PORTION OF SE QUARTER OF SEC 27, TWN 20 N, RGE. 4 E, W.M.  
CITY OF PUYALLUP, PIERCE COUNTY, WASHINGTON  
**EXISTING CONDITIONS / DEMOLITION PLAN**

PORTION OF SE QUARTER OF SEC 27, TWN 20 N, RGE. 4 E, W.M.  
CITY OF PUYALLUP, PIERCE COUNTY, WASHINGTON  
**ROUGH GRADING & TESC PLAN**

Title: **ROUGH GRADING SECTIONS**  
**FORTRESS - PUYALLUP**

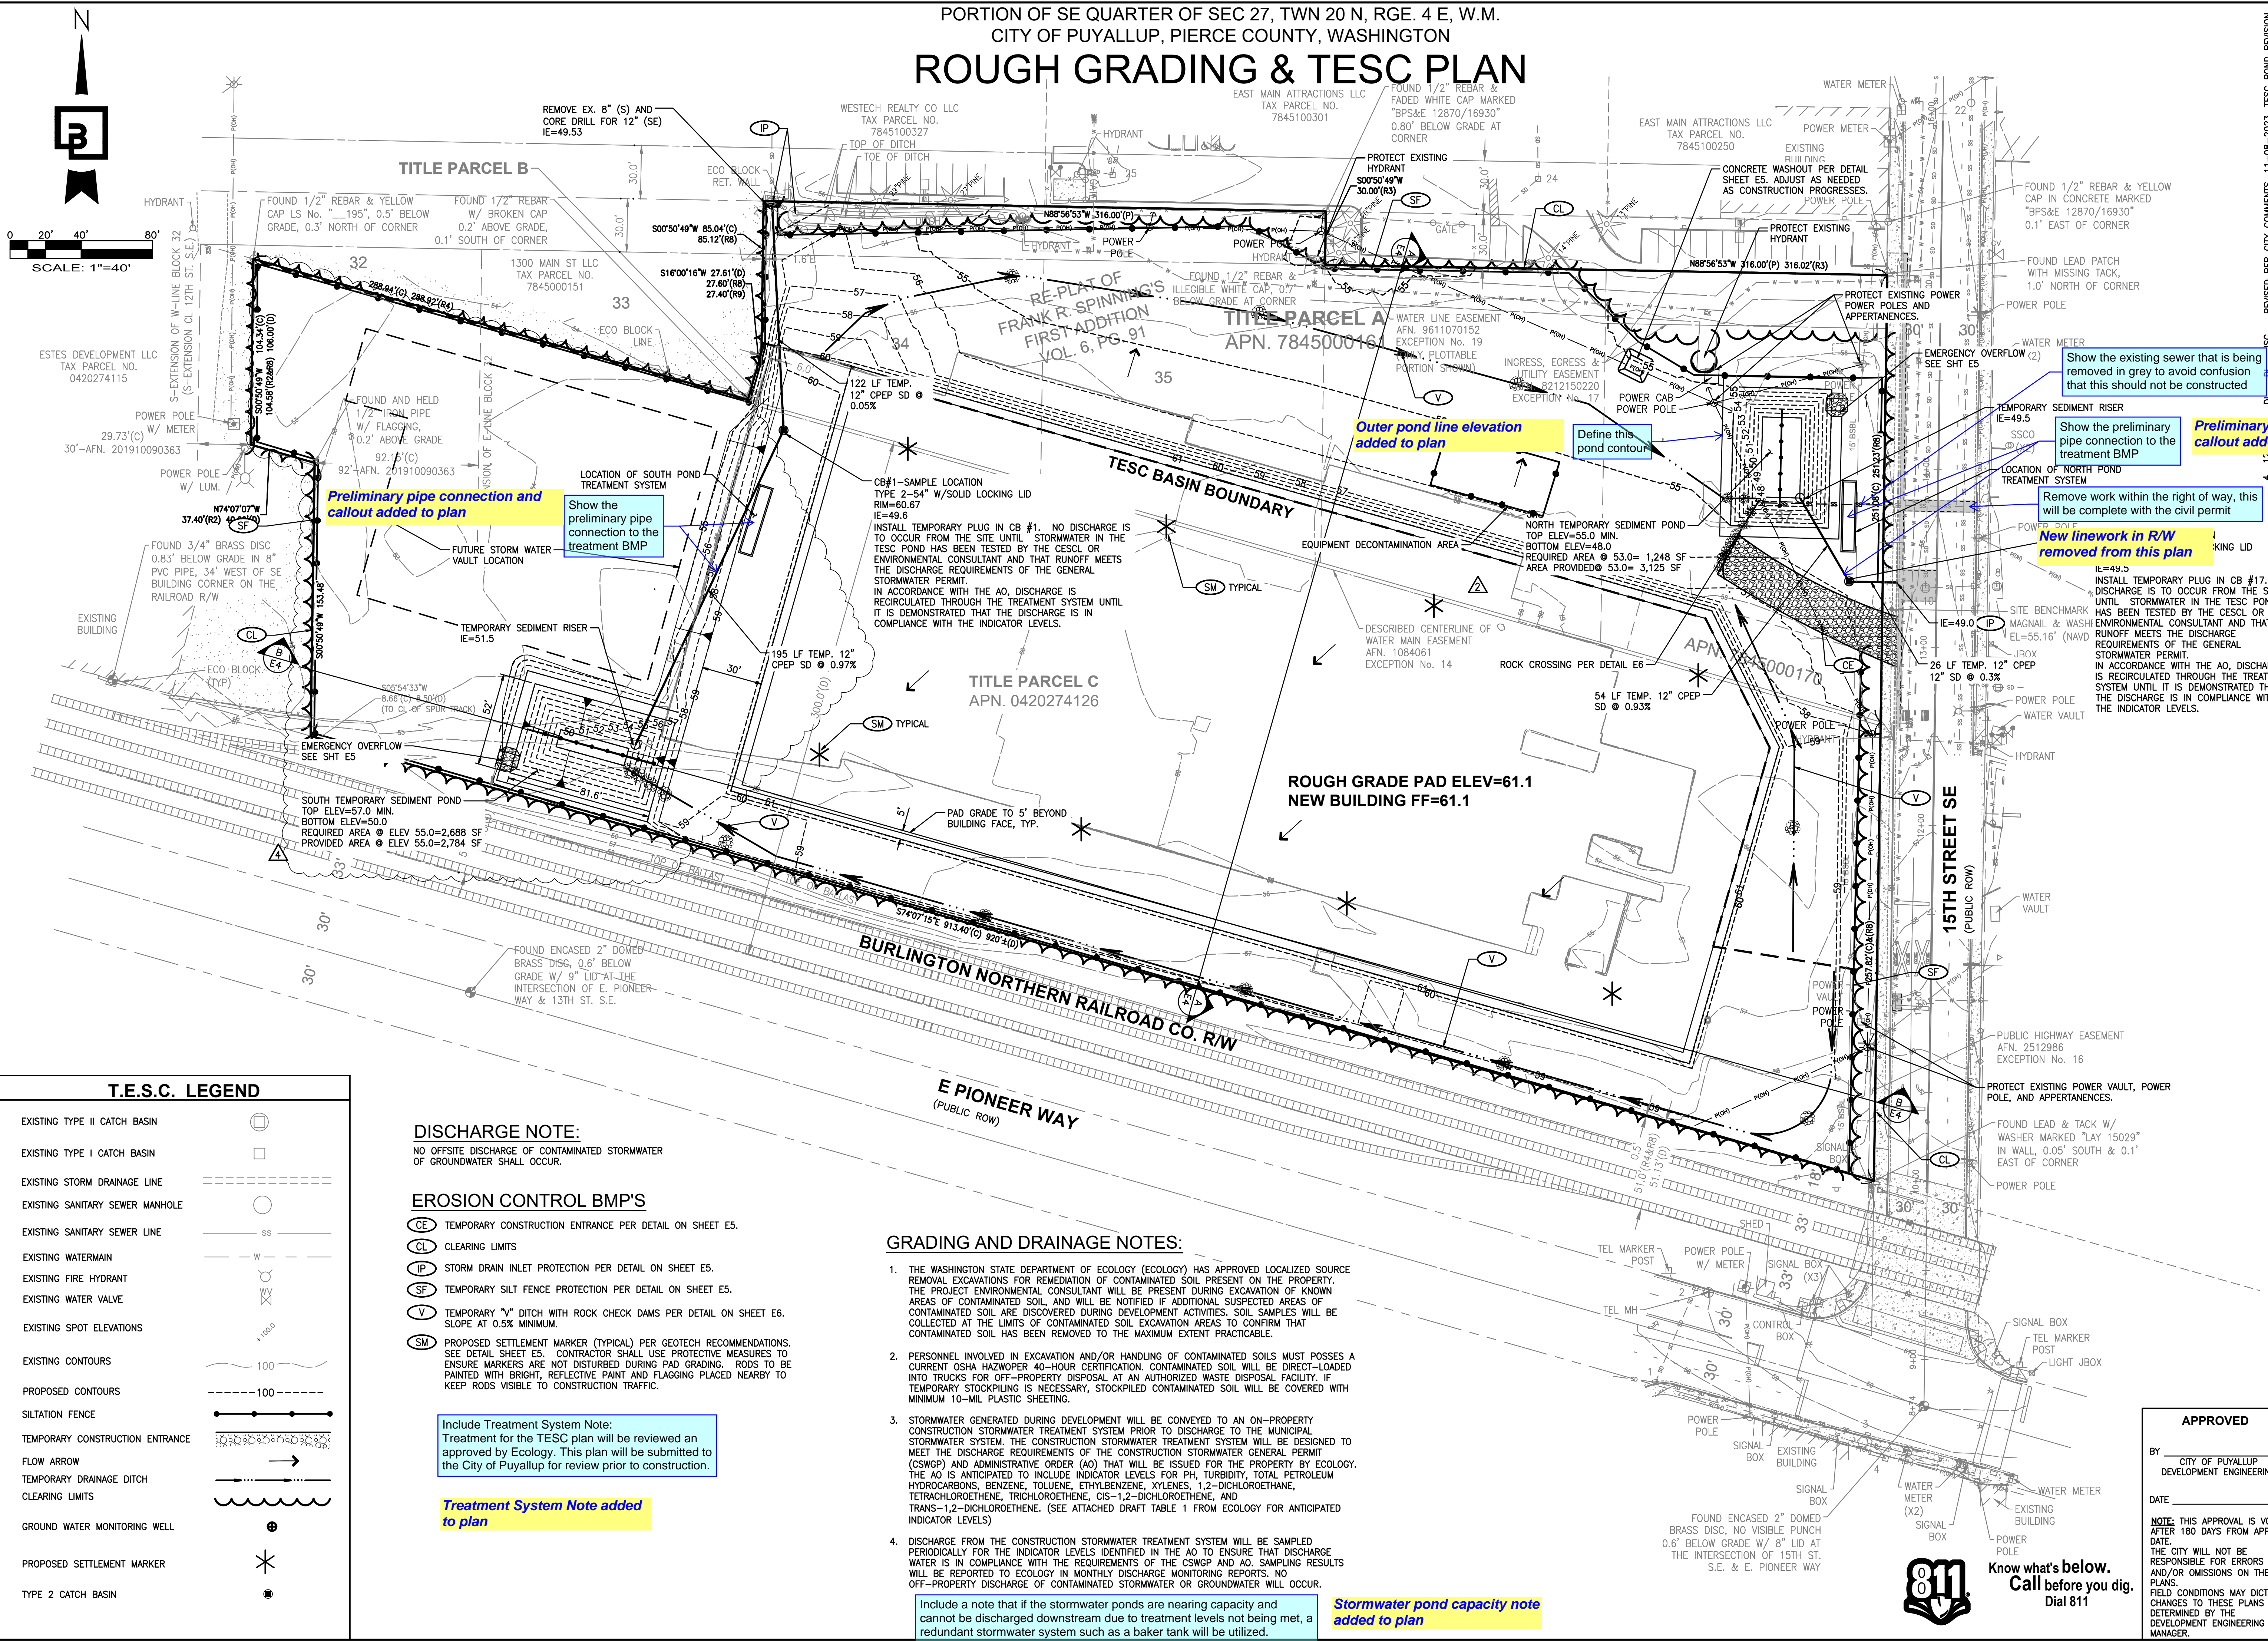
**Treatment System Note added to plan**

**Stormwater pond capacity note added to plan**

**Treatment System Note:**  
Treatment for the TESC plan will be reviewed and approved by Ecology. This plan will be submitted to the City of Puyallup for review prior to construction.

- GRADING AND DRAINAGE NOTES:**
- THE WASHINGTON STATE DEPARTMENT OF ECOLOGY (ECOLGY) HAS APPROVED LOCALIZED SOURCE REMOVAL EXCAVATIONS FOR REMEDIATION OF CONTAMINATED SOIL PRESENT ON THE PROPERTY. THE PROJECT ENVIRONMENTAL CONSULTANT WILL BE PRESENT DURING EXCAVATION OF KNOWN AREAS OF CONTAMINATED SOIL, AND WILL BE NOTIFIED IF ADDITIONAL SUSPECTED AREAS OF CONTAMINATED SOIL ARE DISCOVERED DURING DEVELOPMENT ACTIVITIES. SOIL SAMPLES WILL BE COLLECTED AT THE LIMITS OF CONTAMINATED SOIL EXCAVATION AREAS TO CONFIRM THAT CONTAMINATED SOIL HAS BEEN REMOVED TO THE MAXIMUM EXTENT PRACTICABLE.

- STORMWATER GENERATED DURING DEVELOPMENT WILL BE CONVEYED TO AN ON-PROPERTY CONSTRUCTION STORMWATER TREATMENT SYSTEM PRIOR TO DISCHARGE TO THE MUNICIPAL STORMWATER SYSTEM. THE CONSTRUCTION STORMWATER TREATMENT SYSTEM WILL BE DESIGNED TO MEET THE DISCHARGE REQUIREMENTS OF THE CONSTRUCTION STORMWATER GENERAL PERMIT (CSWGP) AND ADMINISTRATIVE ORDER (AO) THAT WILL BE ISSUED FOR THE PROPERTY BY ECOLOGY. THE AO IS ANTICIPATED TO INCLUDE INDICATOR LEVELS FOR PH, TURBIDITY, TOTAL PETROLEUM HYDROCARBONS, BENZENE, TOLUENE, ETHYLBENZENE, XYLENES, 1,2-DICHLOROETHANE, TETRACHLOROETHENE, TRICHLOROETHENE, CIS-1,2-DICHLOROETHENE, AND TRANS-1,2-DICHLOROETHENE. (SEE ATTACHED DRAFT TABLE 1 FROM ECOLOGY FOR ANTICIPATED INDICATOR LEVELS)

- DISCHARGE FROM THE CONSTRUCTION STORMWATER TREATMENT SYSTEM WILL BE SAMPLED PERIODICALLY FOR THE INDICATOR LEVELS IDENTIFIED IN THE AO TO ENSURE THAT DISCHARGE WATER IS IN COMPLIANCE WITH THE REQUIREMENTS OF THE CSWGP AND AO. SAMPLING RESULTS WILL BE REPORTED TO ECOLOGY IN MONTHLY DISCHARGE MONITORING REPORTS. NO OFF-PROPERTY DISCHARGE OF CONTAMINATED STORMWATER OR GROUNDWATER WILL OCCUR.
